RE: ADDENDUM NO. 1
For RFCSP NO. 2021-229-05-05-JDC
“Construction of New Justice Center – PCT. 4”

ADDENDUM NO. 1

RFCSP NO. 2021-229-05-05-JDC
“Construction of New Justice Center – PCT.4”

AS1.1

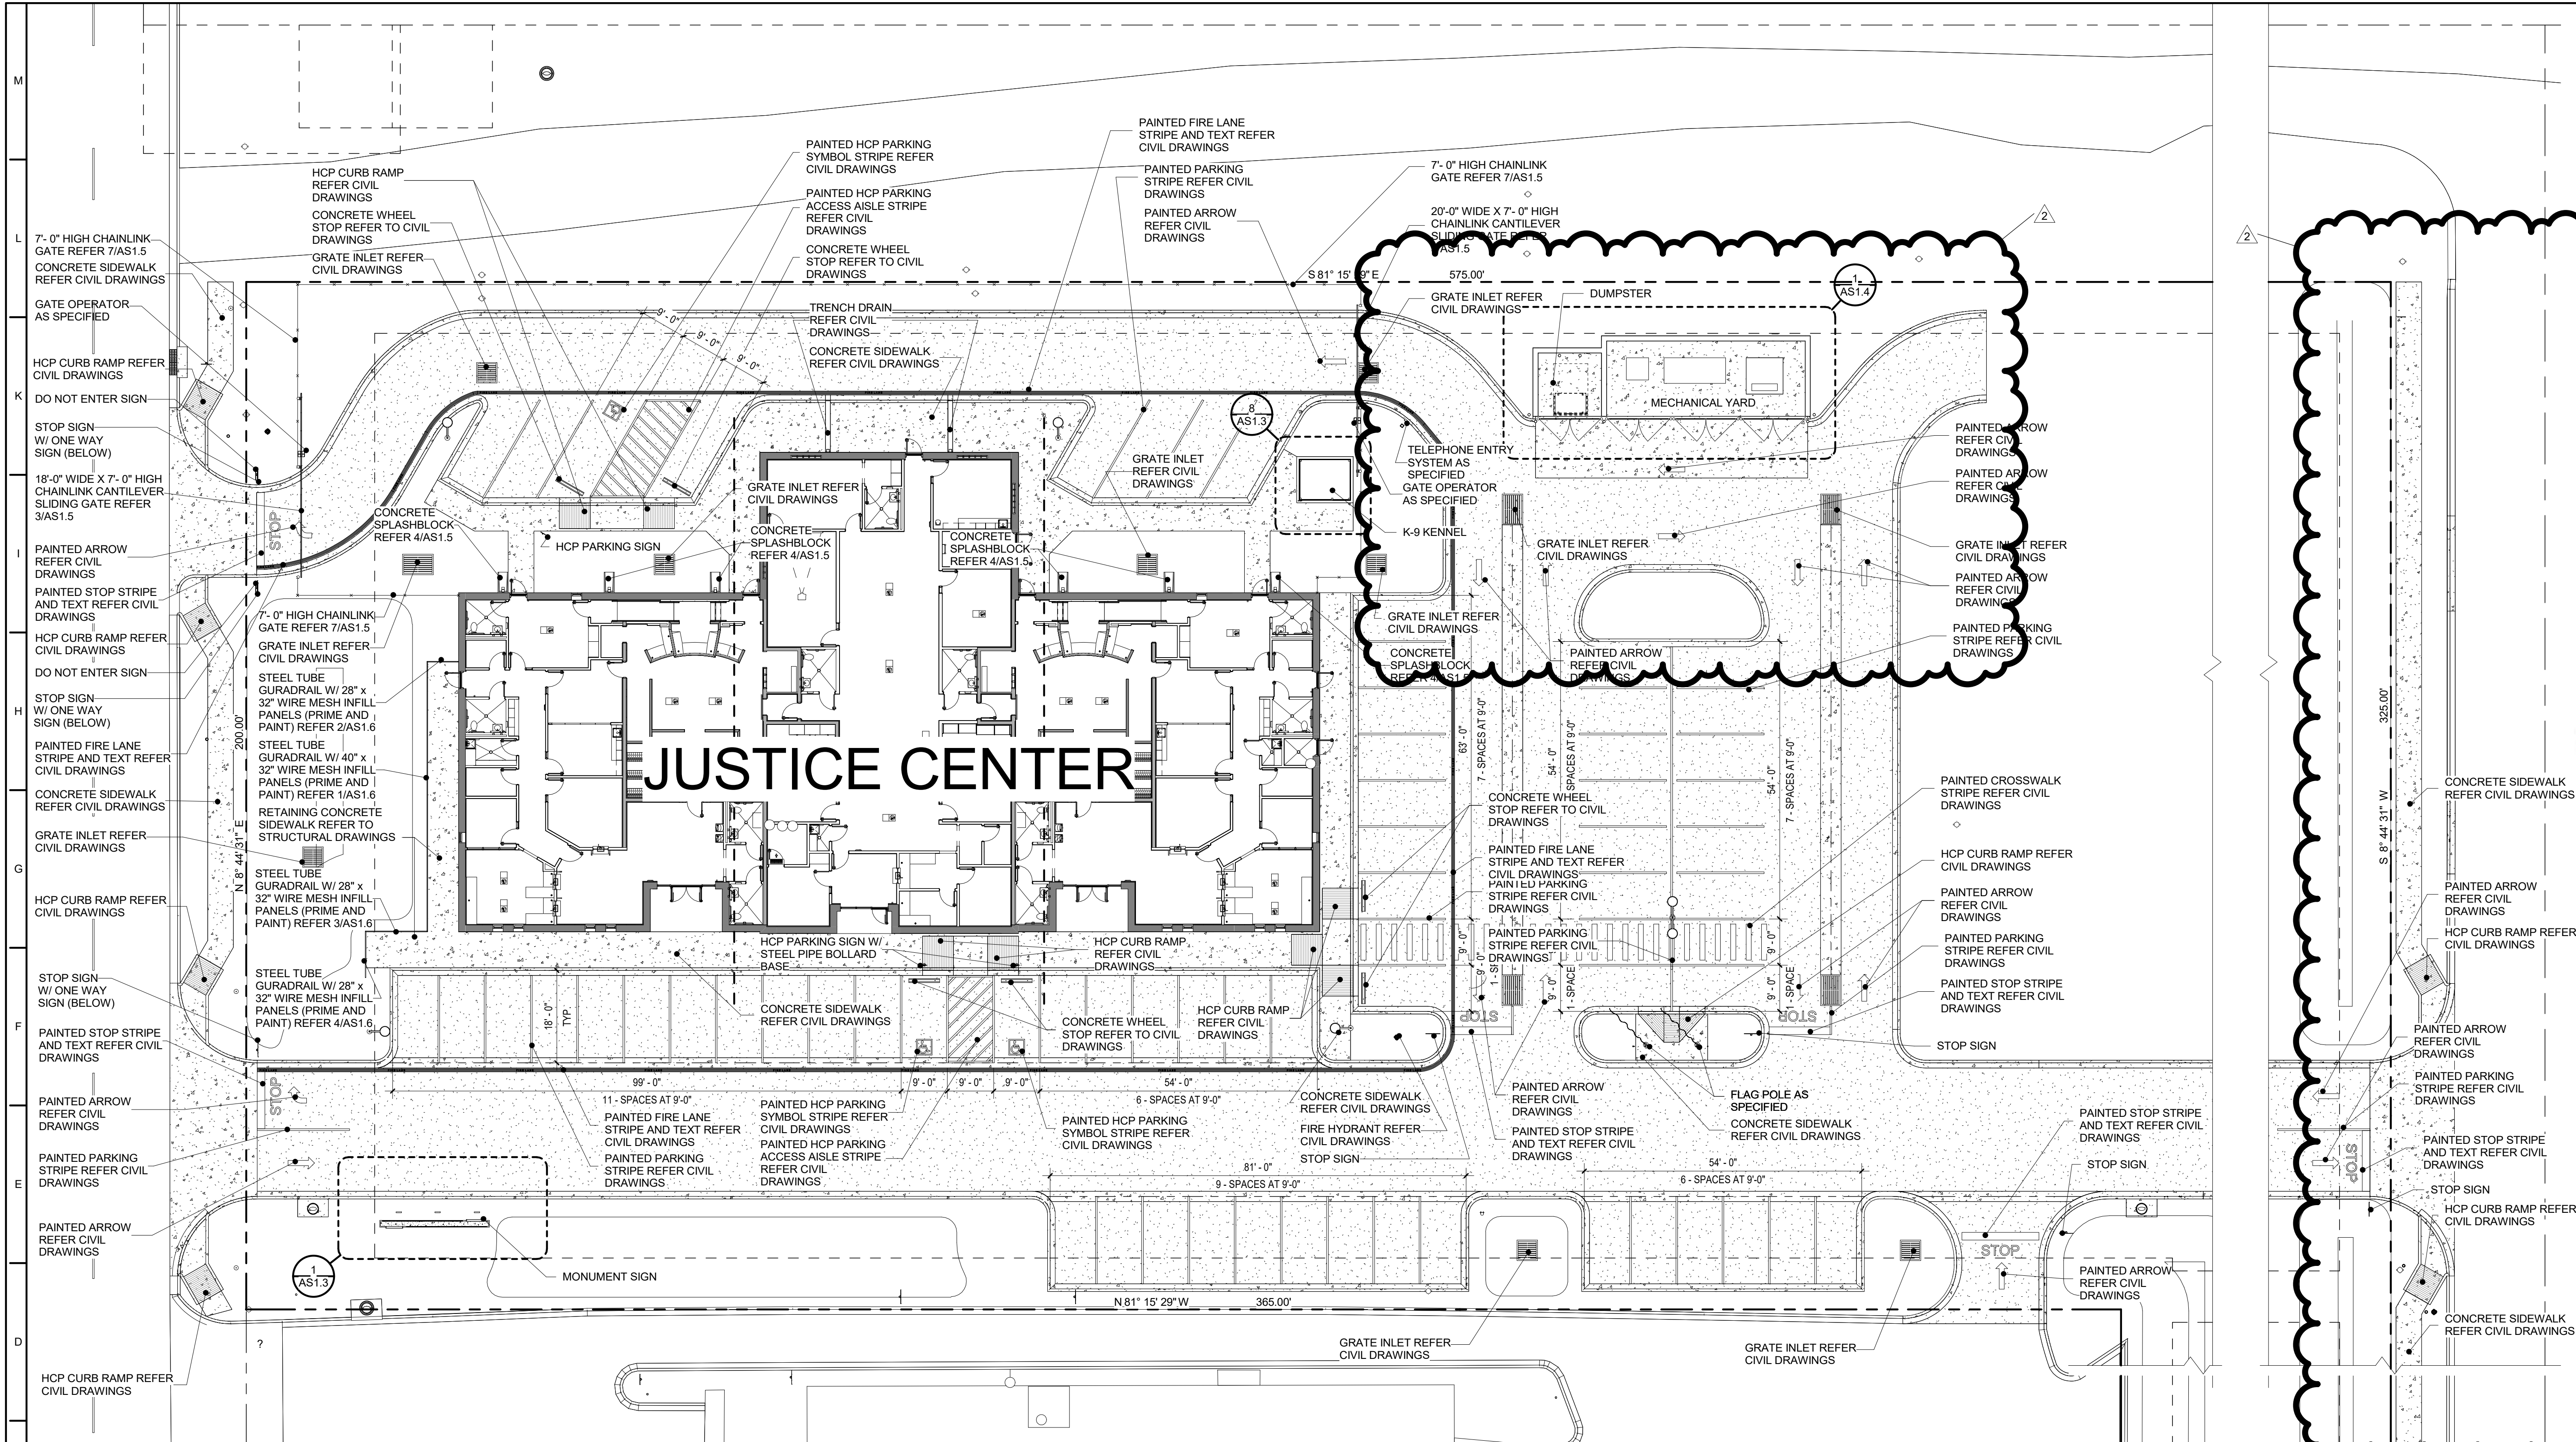
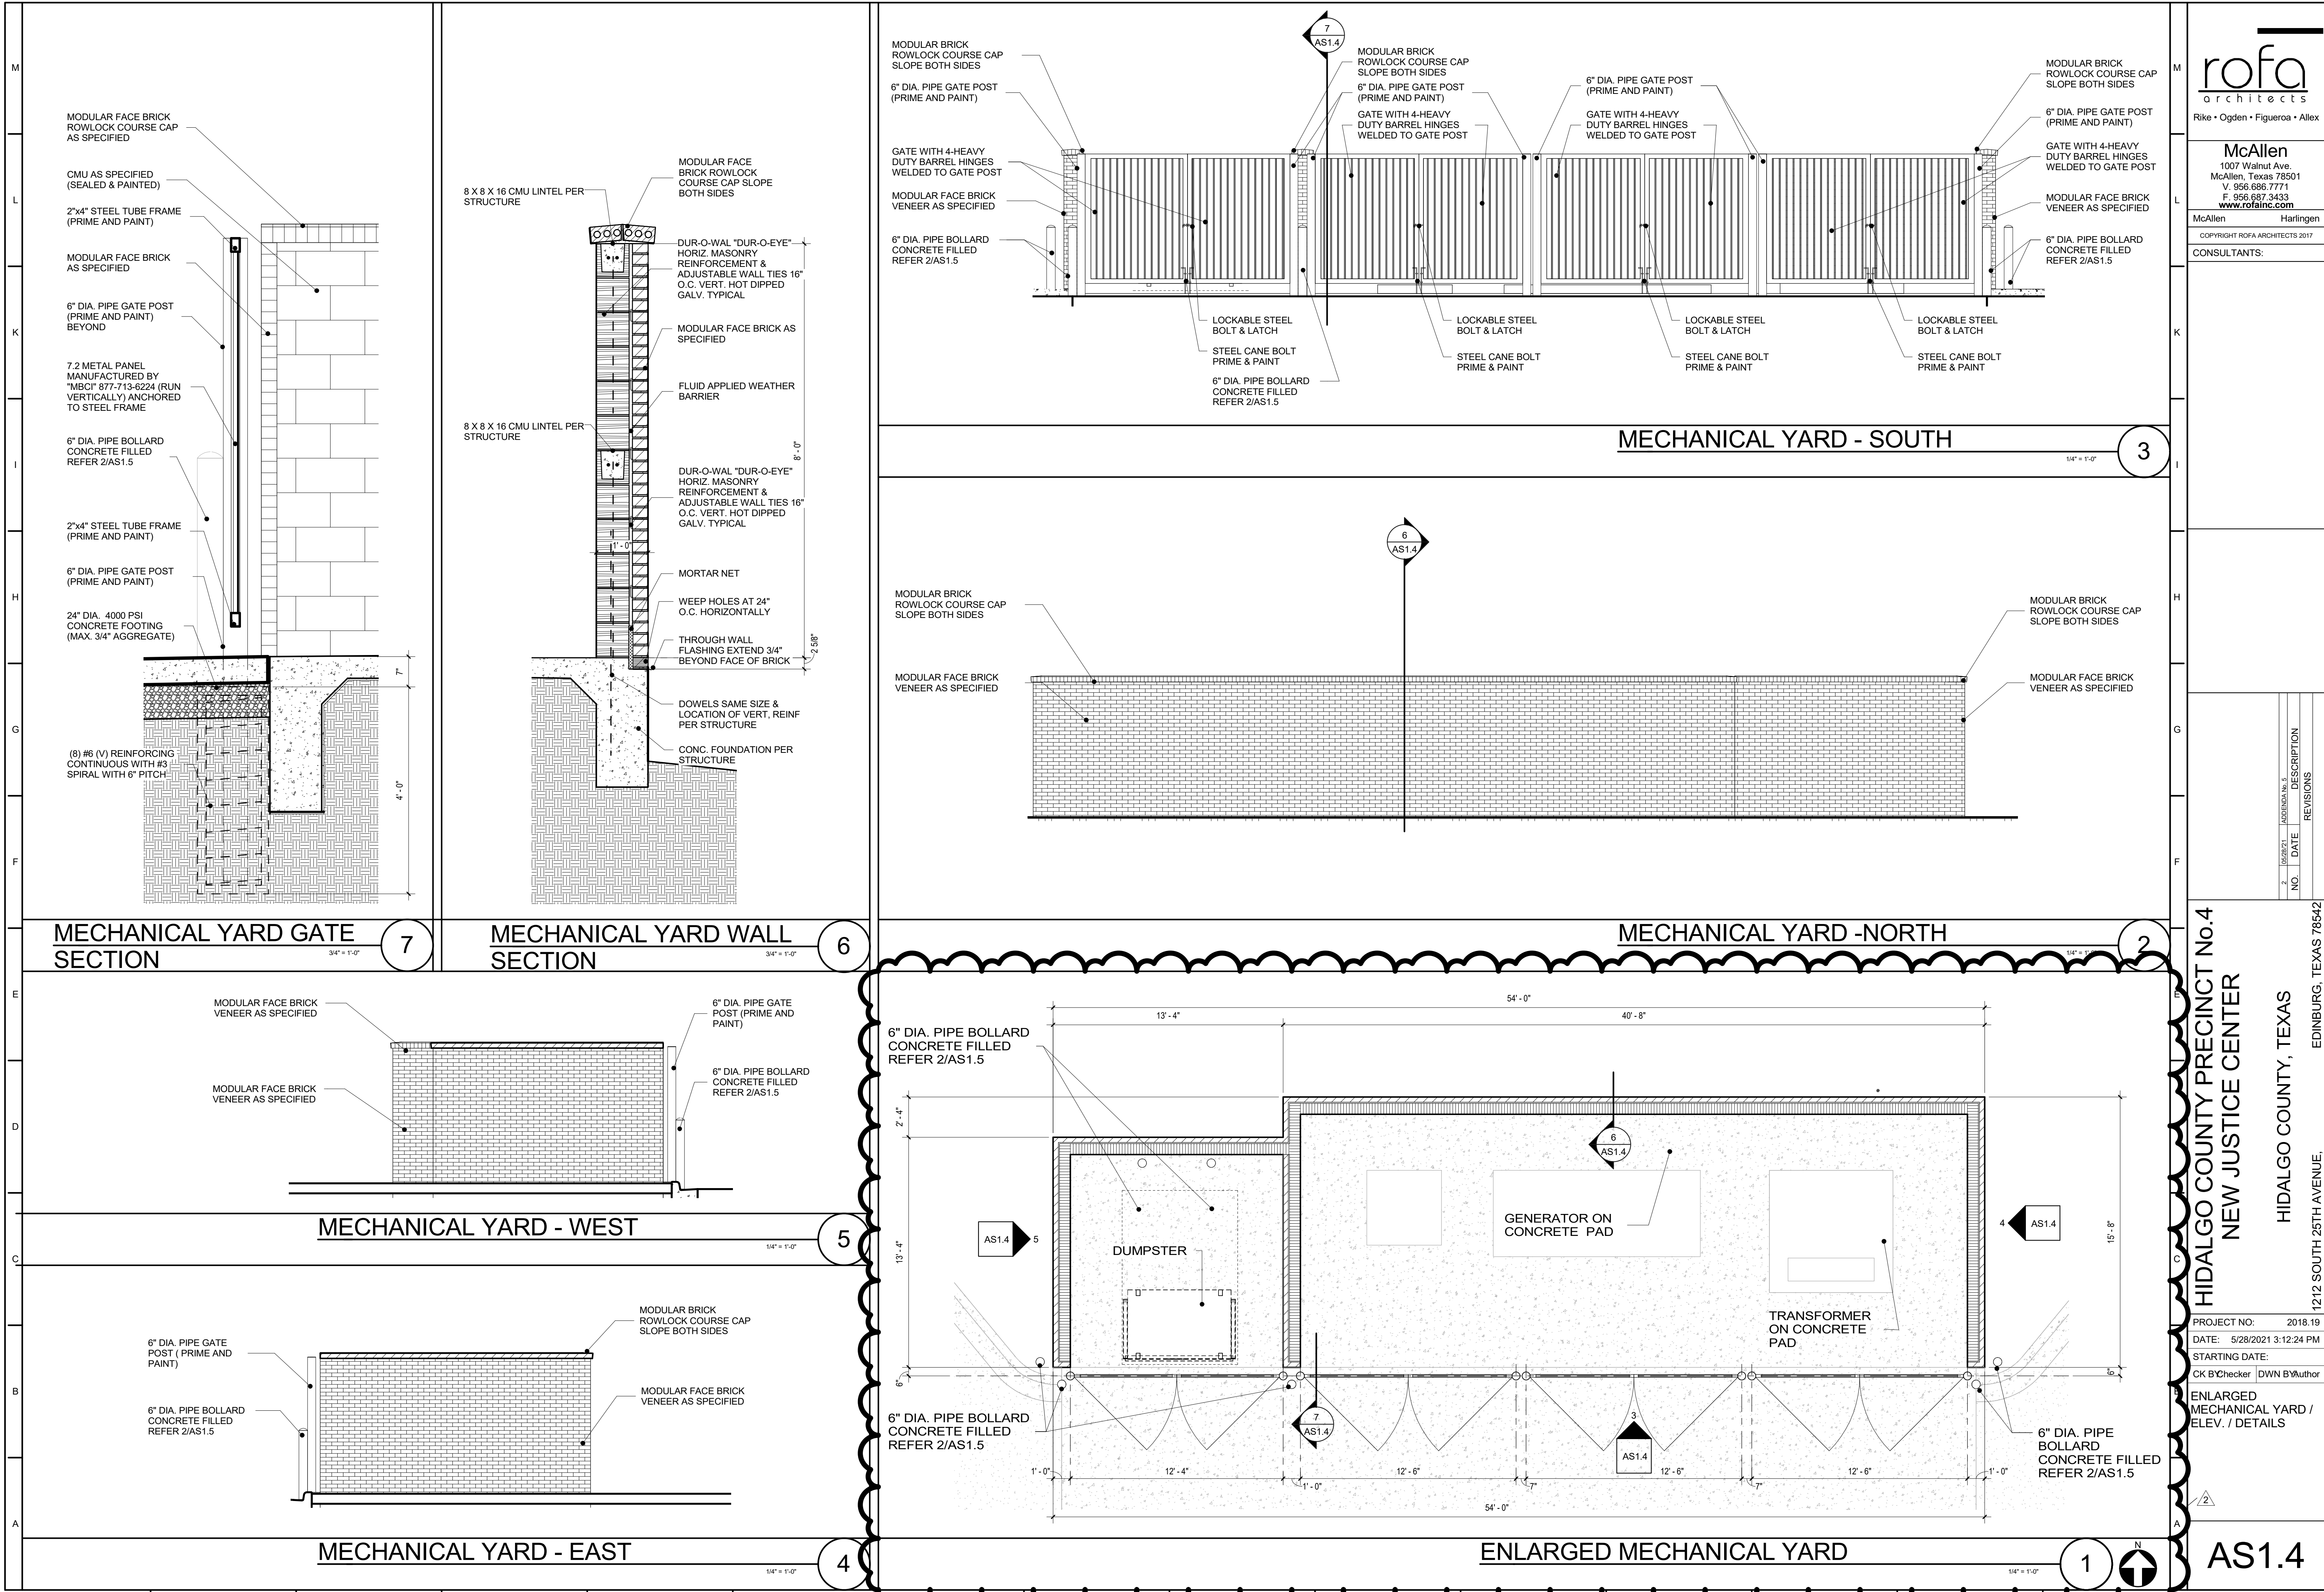
ITEM NO. 16 : ARCHITECTURAL SITE PLAN CHANGES

Per the attached Sheet AS1.1, AS1.2, AS1.3 & AS1.4 please find Architectural Site Plan Changes.
